The Commission has issued the enclosed Amendment Nos. 75 and 72 to Facility Licenses Nos. DPR-33 and DPR-52 for the Browns Ferry Nuclear Plant, Units Nos. 1 and 2. These amendments are in response to your letter of April 9, 1981 (TVA BFNP TS 156), as supplemented by letters dated June 8, 1981, July 2, 1981; July 31, 1981; and August 17, 1981.

BROWNS FERRY NUCLEAR PLANT, UNIT NO. 1

AMENDMENT TO FACILITY OPERATING LICENSE

Amendment No. 75
License No. DPR-33

BROWNS FERRY NUCLEAR PLANT
 FINAL SAFETY
 ANALYSIS REPORT
 For Diagram of Stand-by Auxiliary
 Power System - Units 1 and 2
 FIGURE 8.3-1b

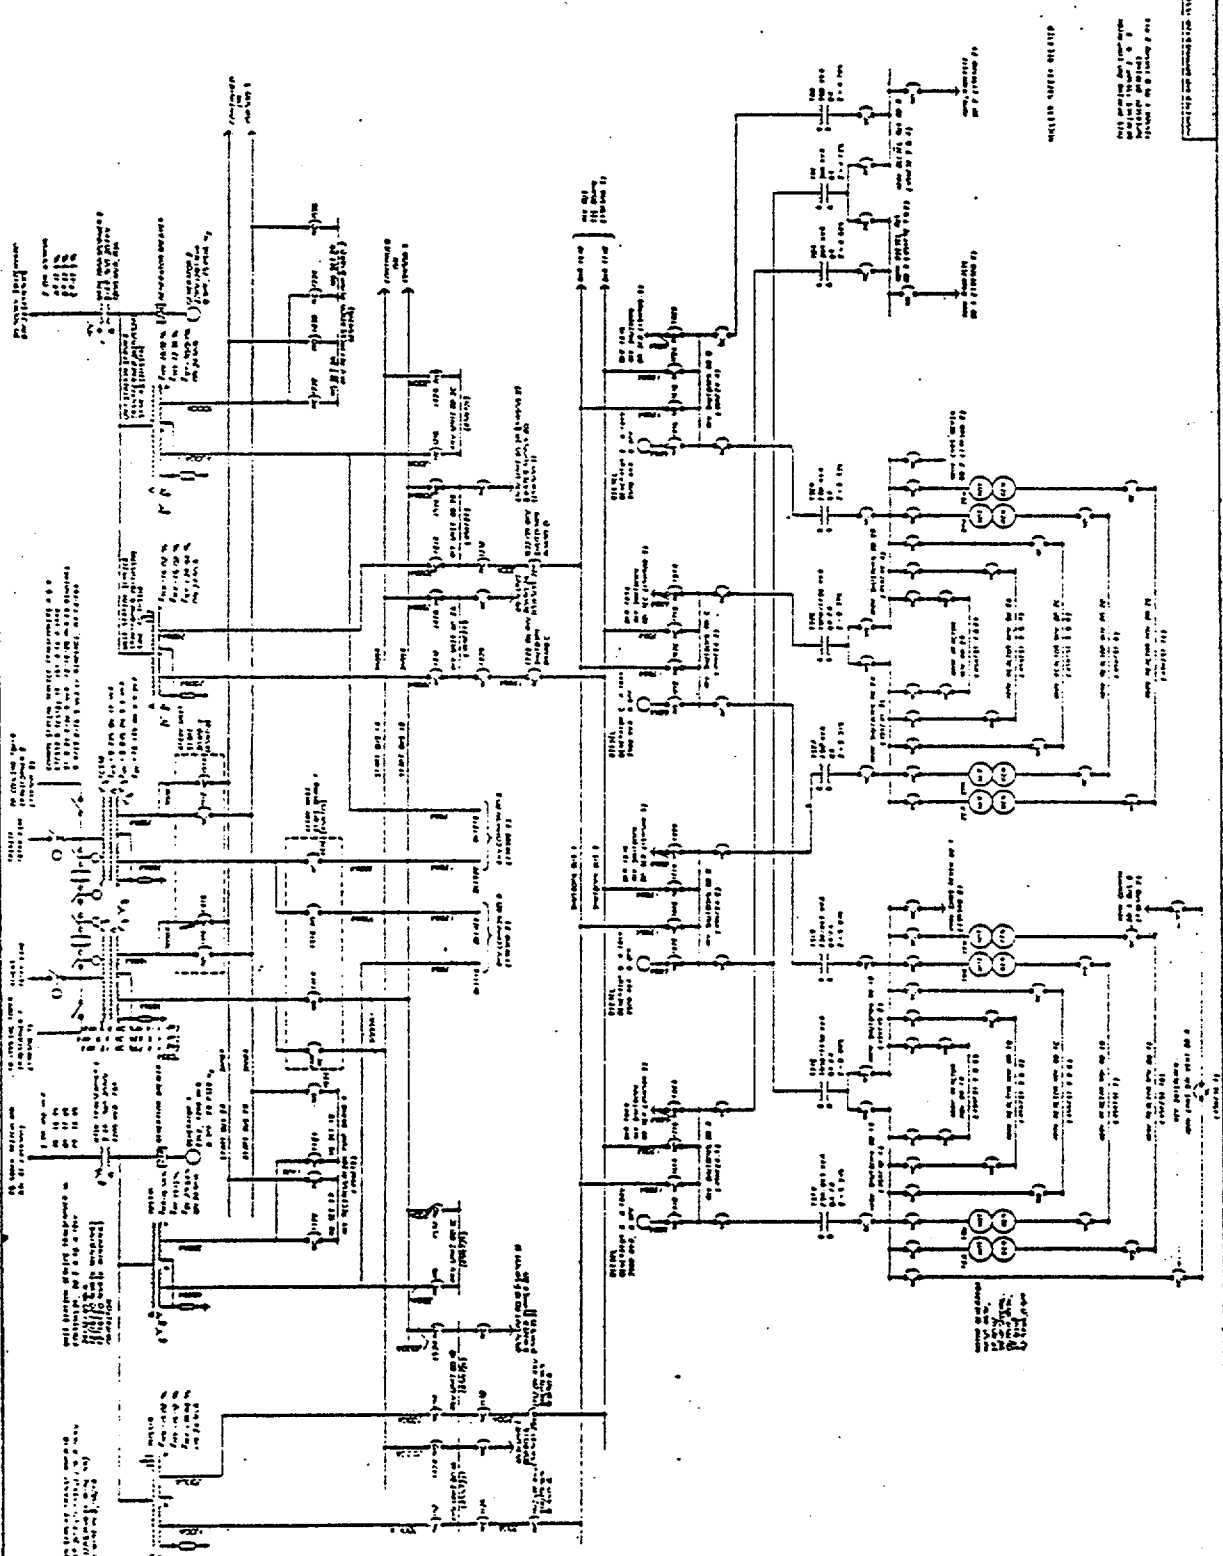
Figure 8.3-1b, attached to this safety evaluation, shows the electrical distribution systems for Browns Ferry Units 1 and 2 is from the material submitted by TVA.(2) The four shutdown boards (A, B, C and D) are powered by shutdown buses 1 or 2, which derive their power from unit boards 1A or 2B and 1B or 2A respectively. Shutdown buses 1 and 2 can also be powered by the 4 kV bus tie board associated with Unit 3. The unit boards are normally powered by the 500-kV switchyard through the Unit Station Service Transformers (USST) 1B and 2B. A generator breaker isolates the unit generator from the intermediate voltage (22 kV) isolated phase bus on a unit trip. Unit boards 1A, 1B, 2A and 2B can also be powered by the 161 kV grid via the Common Station Service Transformers (CSST) A or B. The 4 kV bus tie is also connected to the 161 kV grid via cooling tower transformers (CTT) 1 and 2. Therefore, 4 kV shutdown boards A, B, C and D have a access to two switchyards of different voltages through multiple redundant paths.
